M95512-DF package mechanical data modifications

This errata sheet applies to the M95512-DF, which is 512 bit serial SPI bus EEPROMs, and specifically to the device delivered in 8-bump wafer-level chip-scale packages (WLCSP).

Figure 2. D and E front side view

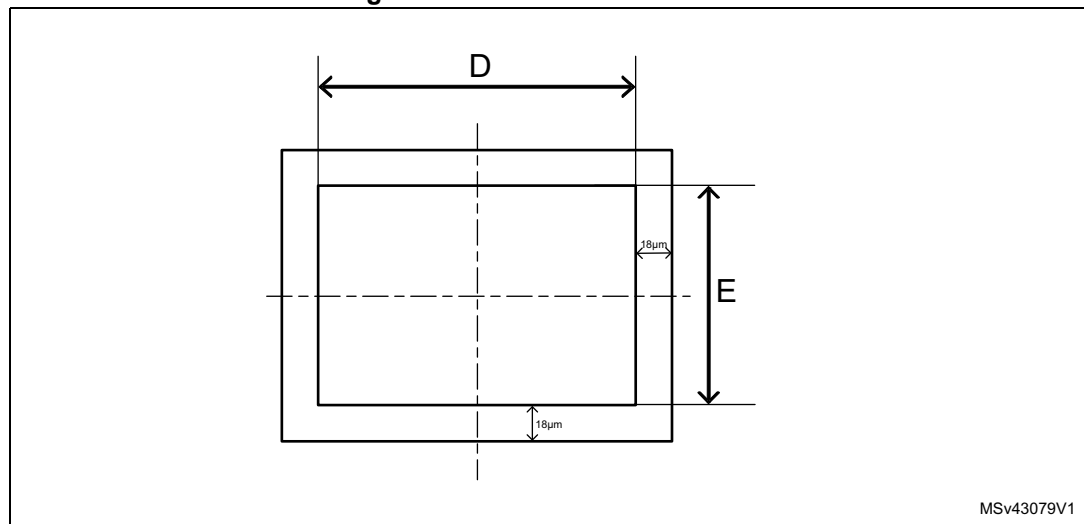
- The D and E values in the M95512-DF datasheet correspond to front side view (ball side), instead of back side view (marking side view).
[Table 2](#) and [Table 3](#) report the data for the front and back view, respectively.

Symbol	Millimeters			Inches		
	Min	Typ	Max	Min	Typ	Max
D	-	1.271	1.291	-	0.0500	0.0508
E	-	1.937	1.957	-	0.0763	0.0770

Figure 3. D and E back side view

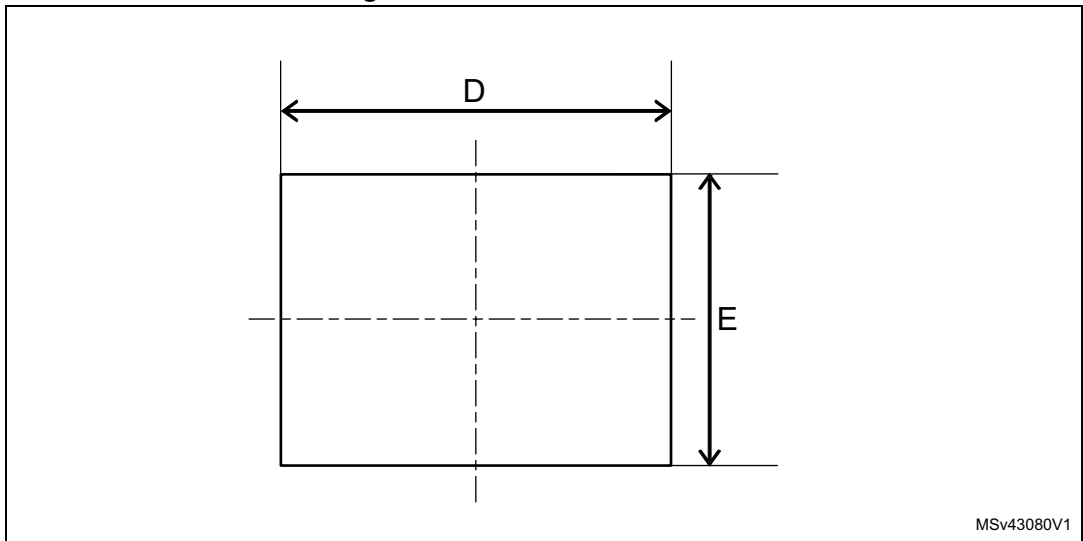
This document refers to the changes in dimensions D and E (see [Figure 3](#)) described in the M95512-DF datasheet, in tables detailing the dimensions of the WLCSP 8-bump package.

D and E values must be modified to correct the following mistake:

Symbol	Millimeters			Inches		
	Min	Typ	Max	Min	Typ	Max
D	-	1.289	1.309	-	0.0507	0.0515
E	-	1.955	1.975	-	0.0770	0.0778

Figure 4. D or E side view

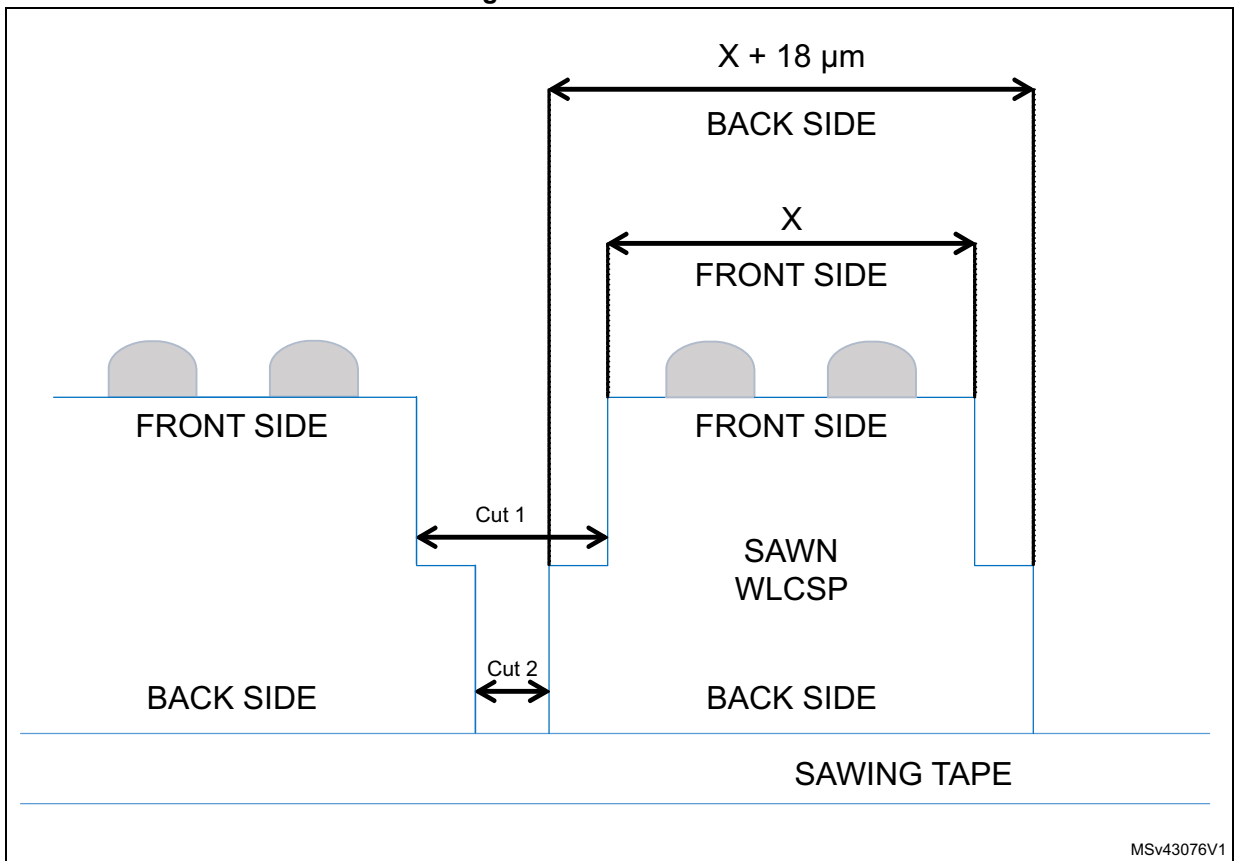
The difference between back side and front side dimension is 18 μm (0.018 mm). This difference is due to the two-step sawing process, where cut 1 and cut 2 are performed with blades having different thicknesses (see [Figure 4](#) in which X represents D or E and it has the same value and tolerance).
